G.E.C. LTD TEL. WKS. COVENTRY.

50 V. R.A.X SYSTEM.

LINE CIRCUIT.

16772
DUPLICATE TRACING.

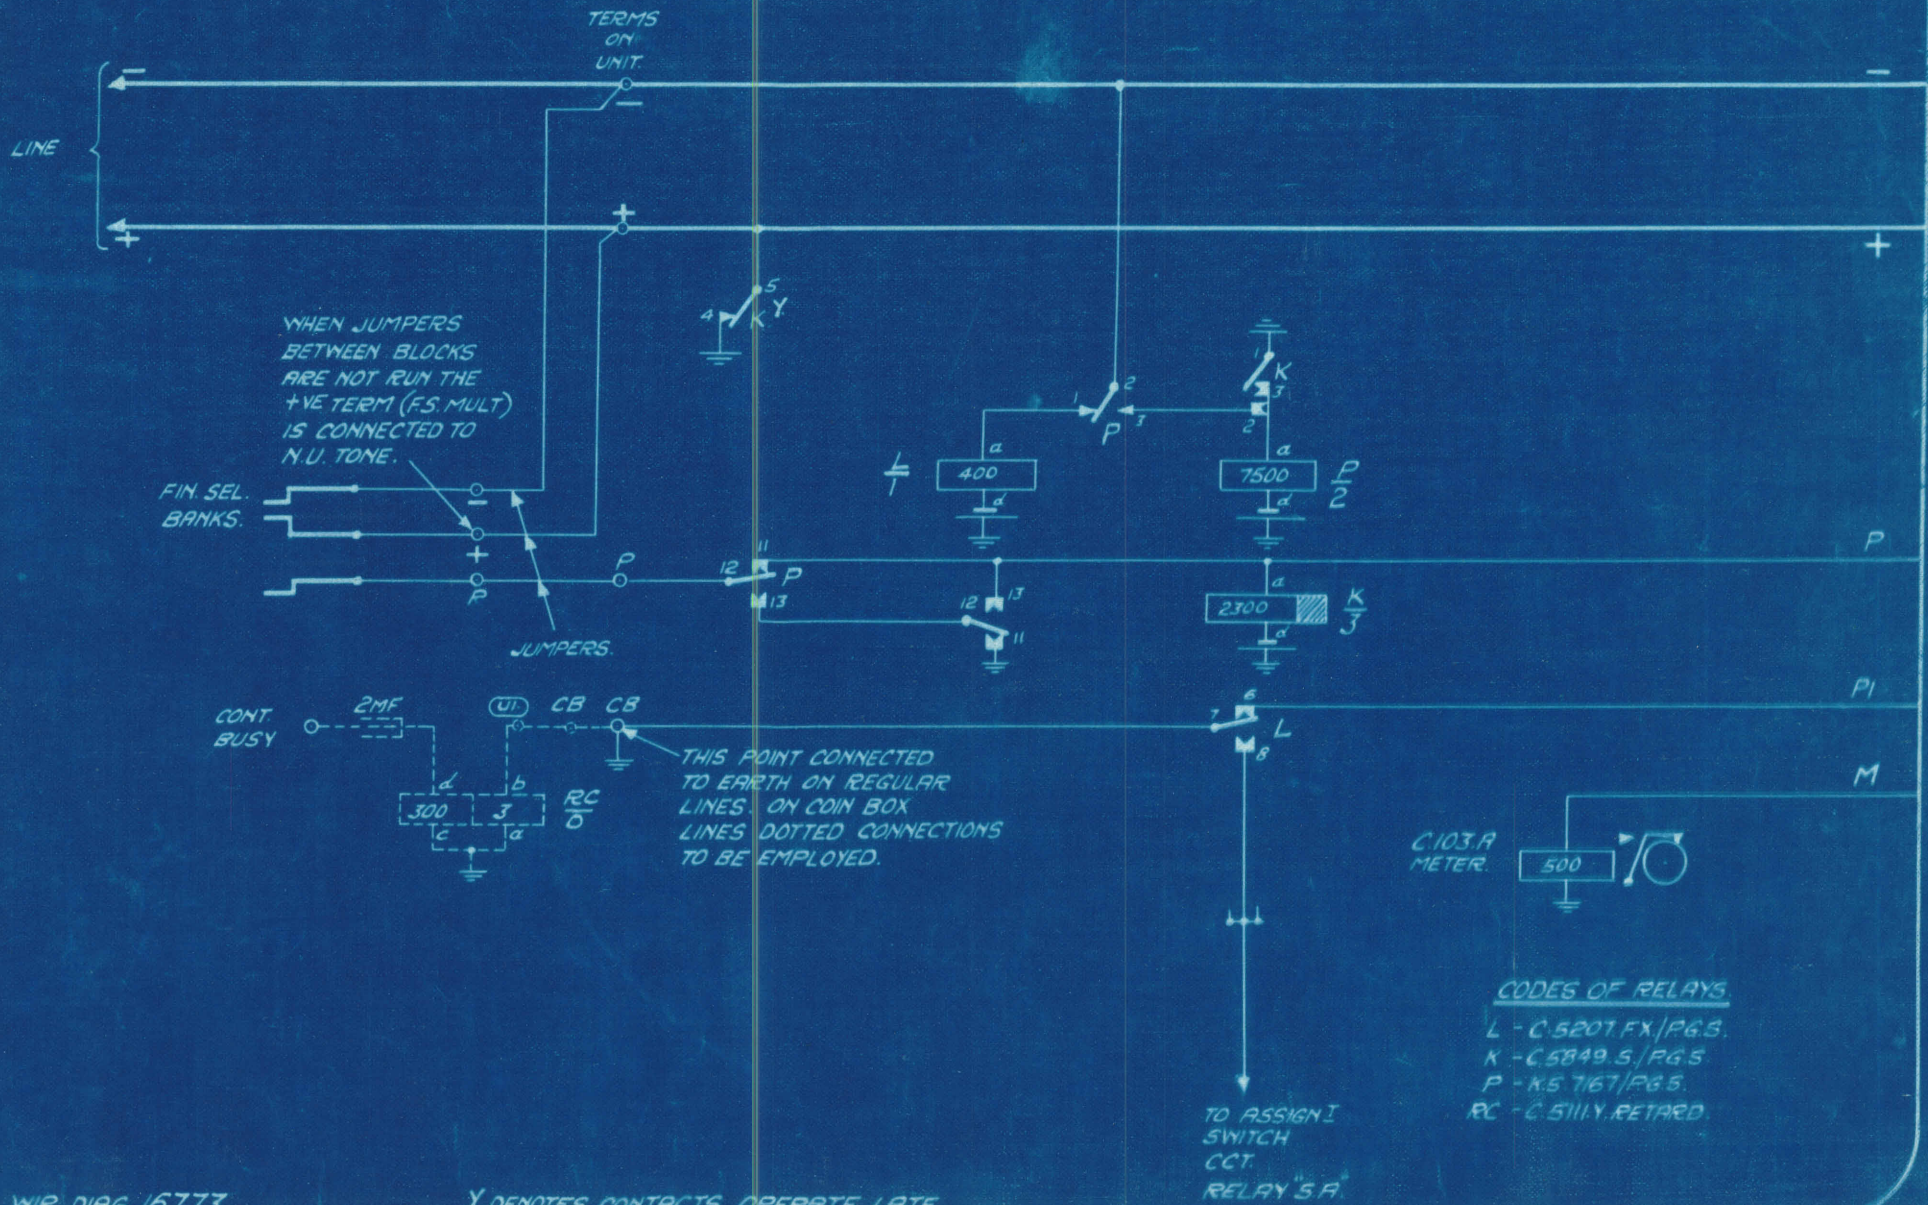
RELAY P WAS C.6708 X / P.G.5
TWIN CONTACTS WERE NOT INDICATED
C.103 A. METER WAS C.104 D.
